IFB No.	17-50 Marshall Elementar	y School Gym	Addition and Renovations
---------	--------------------------	--------------	--------------------------

RE: ADDENDUM NO. 2

Subject: CHANGES TO BIDDING DOCUMENTS

Project: GYM ADDITION AND REMODELING TO MARSHALL ELEMENTARY SCHOOL

FIRST FLOOR NEW WORK PLAN - SANITARY

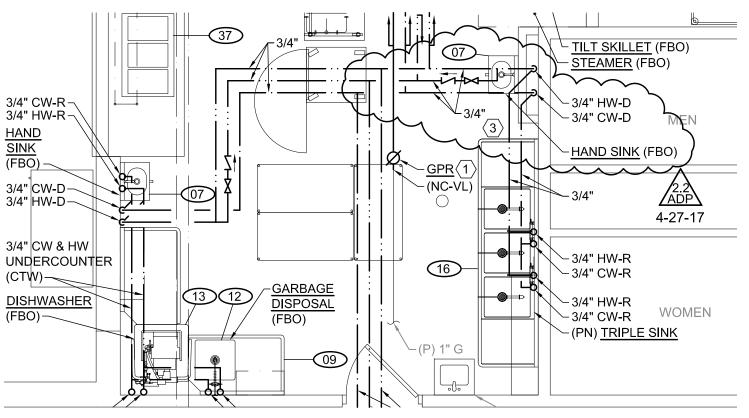
- 14.1. Base Bid First Floor New Work Plan Sanitary, see attached drawing ADP2.1
- 14.2. Base Bid First Floor New Work Plan Water & Gas, see attached drawing ADP2.2

- CUT AND PATCH FLOOR AS REQUIRED FOR NEW SANITARY PIPING. SEE ARCHITECTURAL FLOOR FINISH PLANT.
- ALL HORIZONTAL WATER PIPING AND VENT PIPING FROM THREE COMPARTMENT SINK TO HAND SINK SHALL BE ENCLOSED WITH STAINLESS STEEL METAL.

FIRST FLOOR NEW WORK PLAN - WATER & GAS

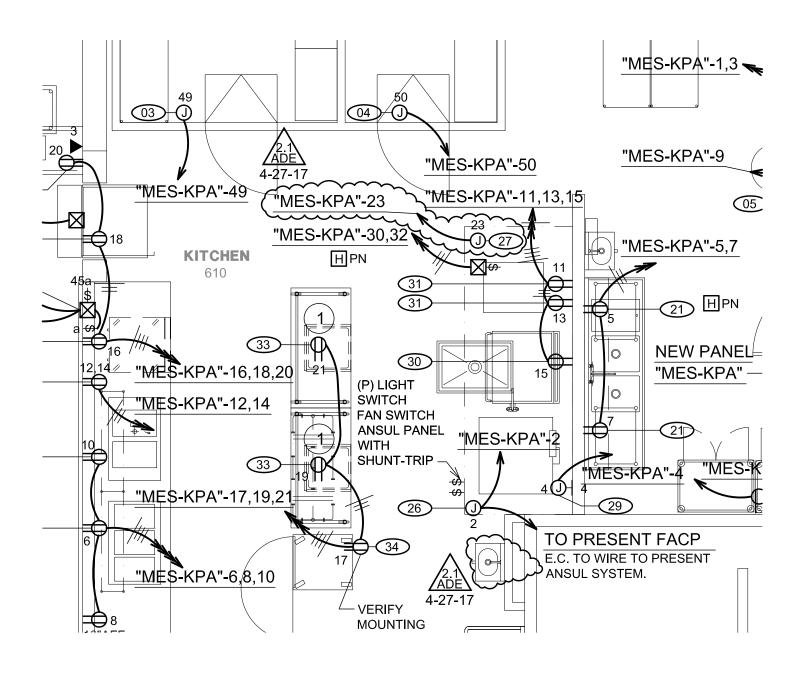
- TIE NEW GAS VENT INTO EXISTING GAS VENT NEARBY.
- ALTERNATE BID #2: THE ASBESTOS CONTRACTOR WILL BE REMOVING PIPE/PIPE FITTING INSULATION THAT EXCEEDS WHAT IS REQUIRED FOR NEW CONSTRUCTION. RE-INSULATING OF PIPE/PIPE FITTING SHALL BE RE-INSULATED BY THE PLUMBING CONTRACTOR, SEE SHEET ASB101 FOR AFFECTED AREAS AND
- PIPERE INSULATING REQUIREMENTS: $\langle 3 \rangle$ ALL HORIZONTAL WATER PIPING AND VENT PIPING FROM THREE COMPARTMENT SINK TO HAND SINK SHALL BE ENCLOSED WITH STAINLESS STEEL METAL.

SHEET NUMBER **FS101**

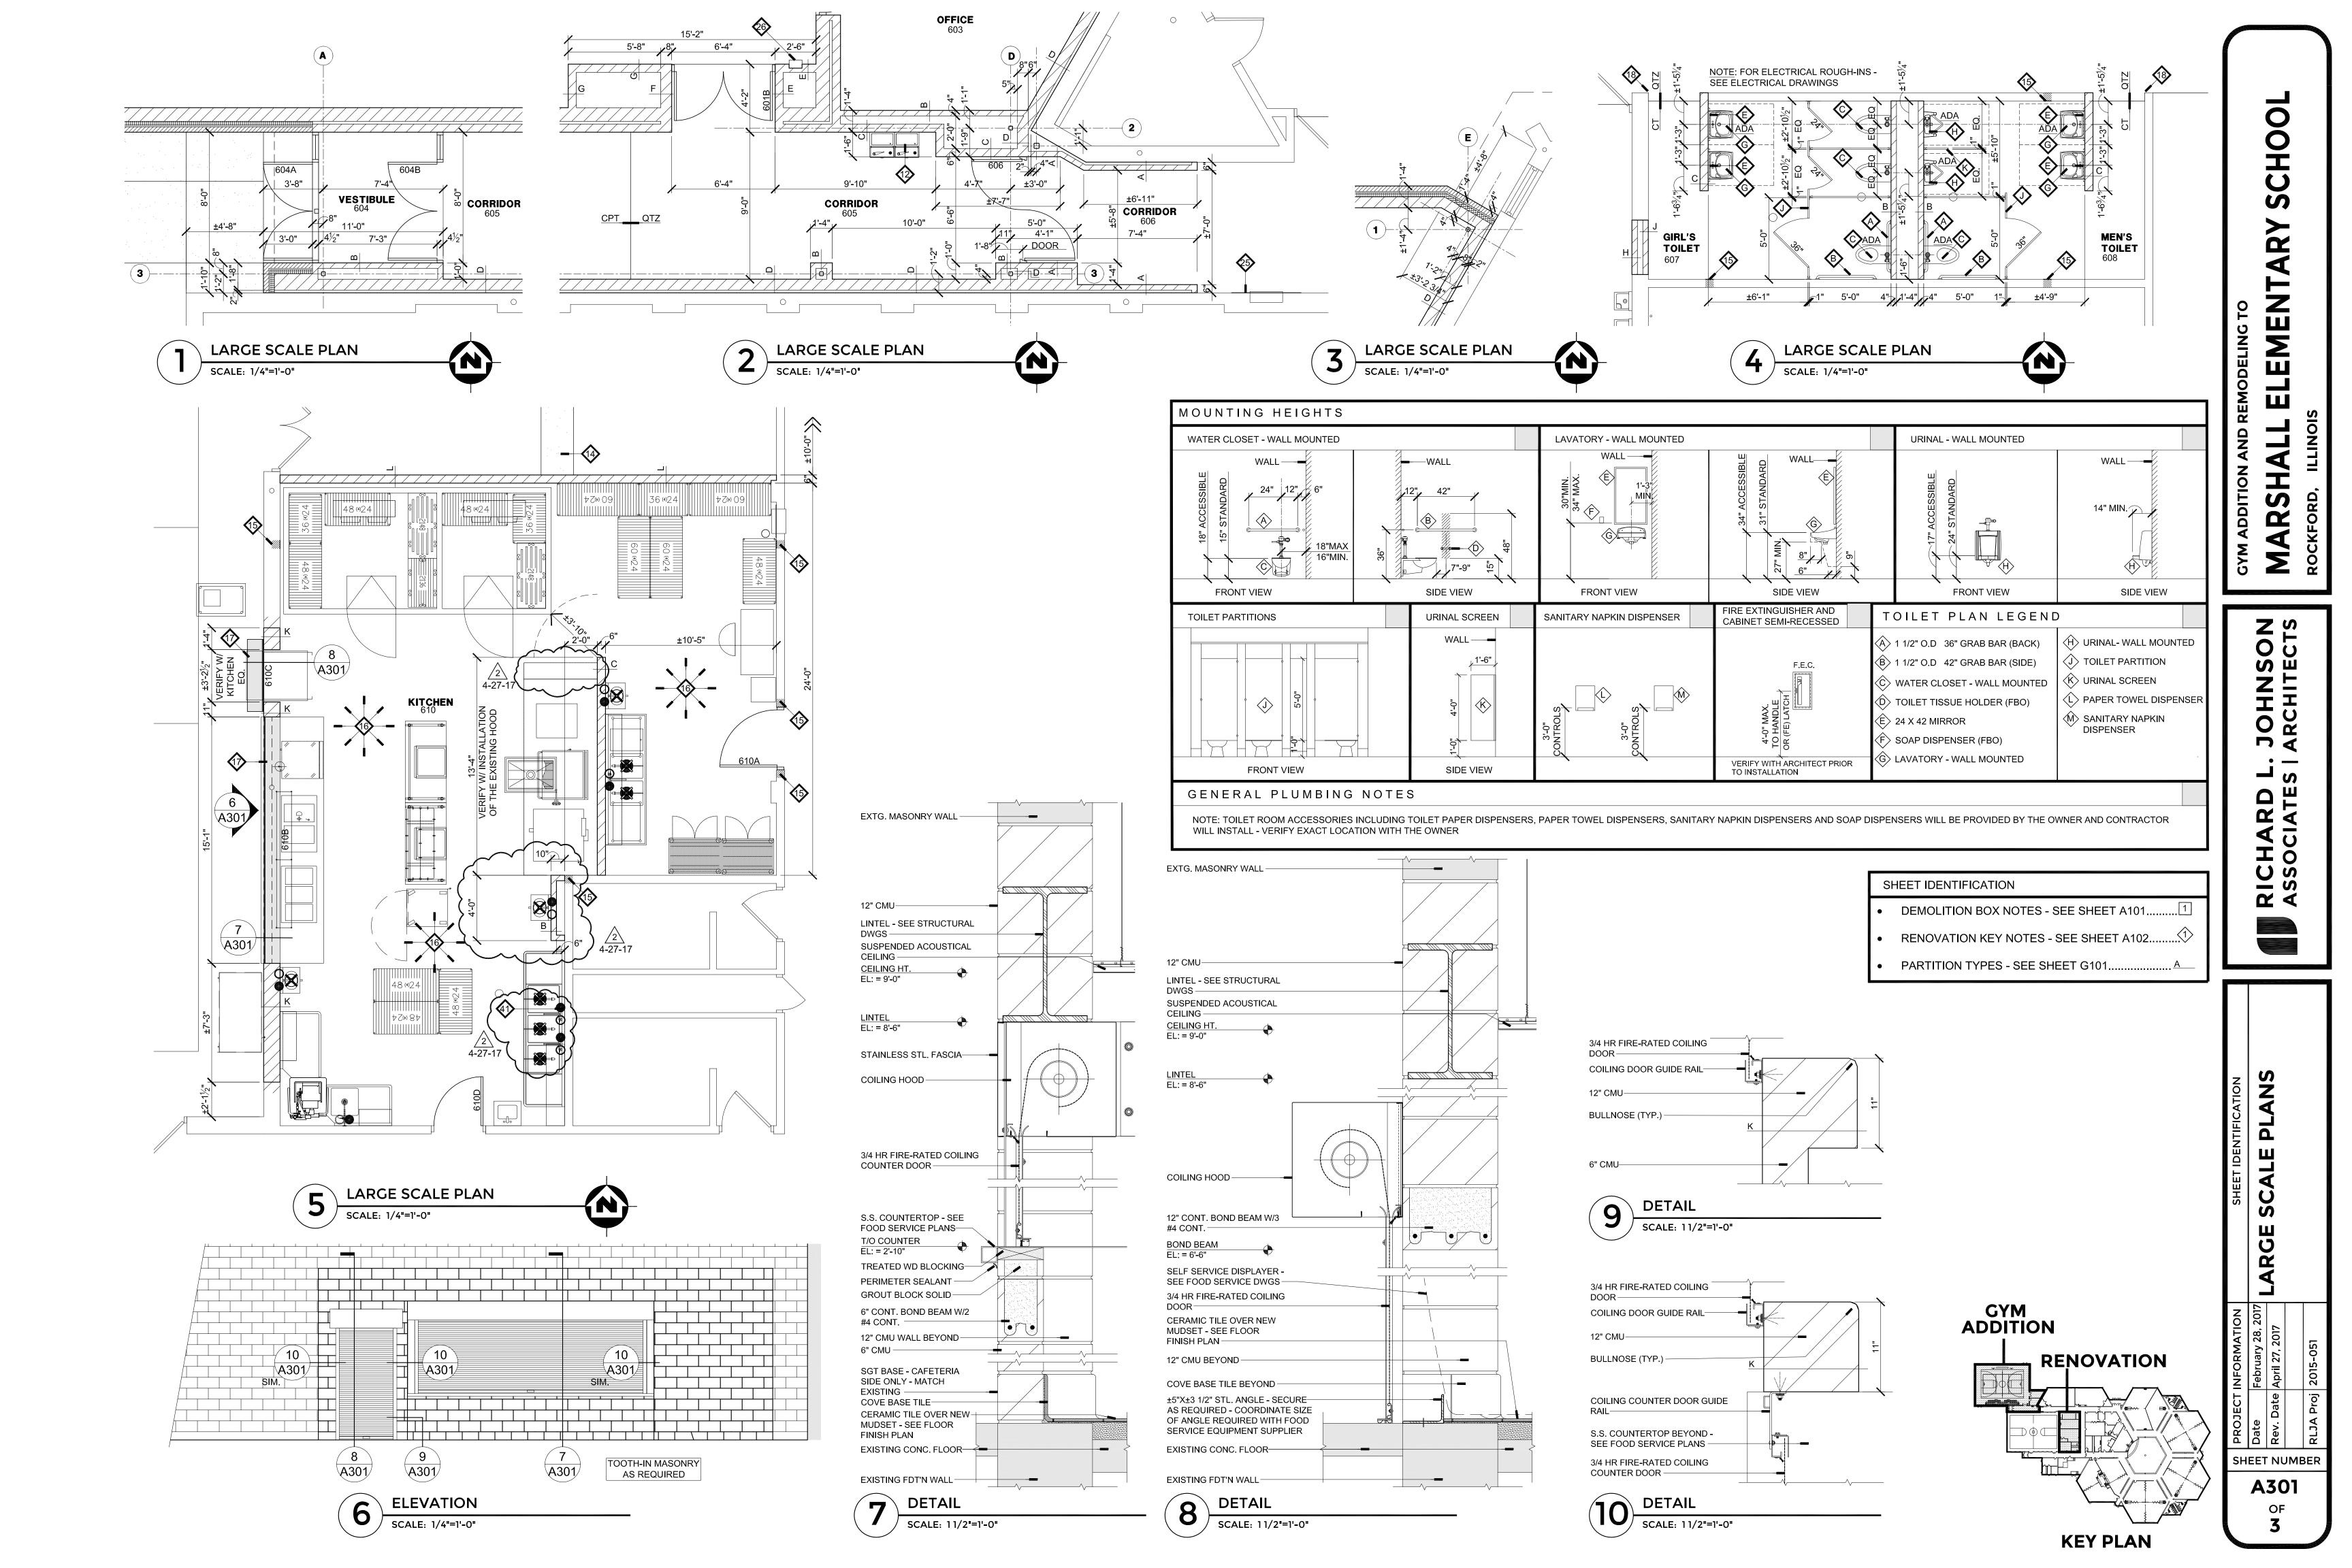
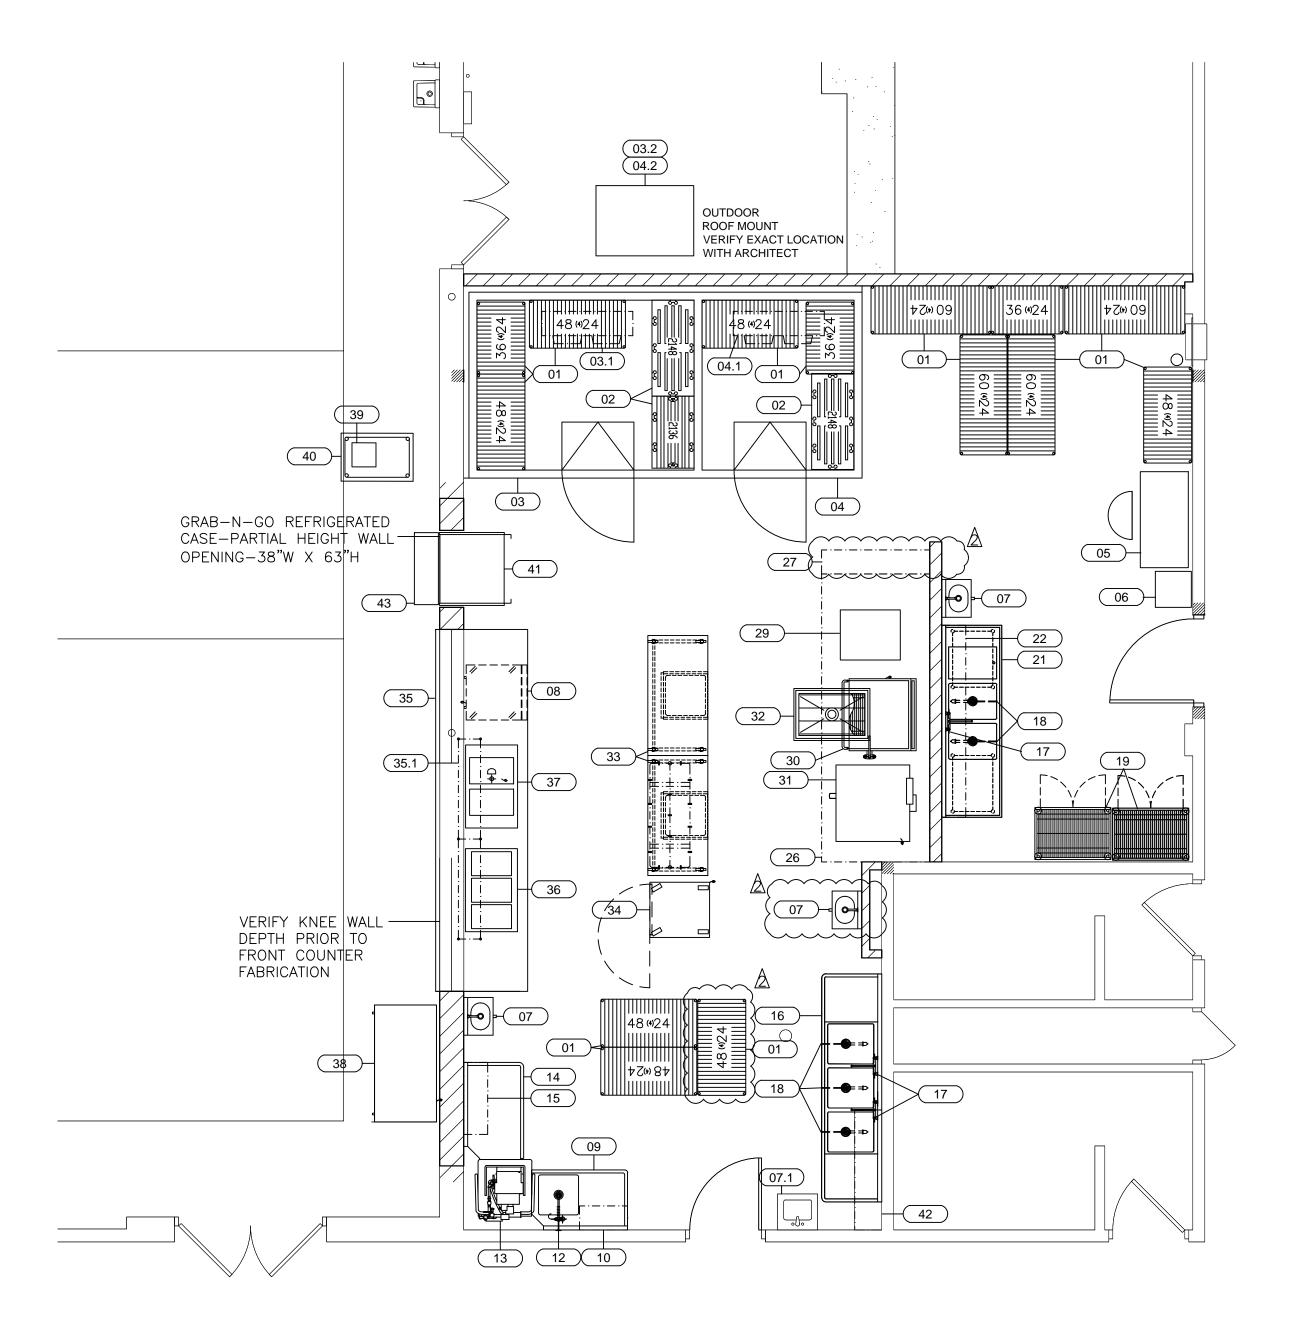
<u>Response:</u> The condensing unit is located on a single story building. Contractor shall visit the site to verify existing conditions.
- Plan Sheet FS101 and the Equipment Schedule on that sheet have missing numbers replaced with squares. Can we receive a corrected sheet FS101 <u>Response:</u> The revised sheet FS 101 will be included in addendum two.
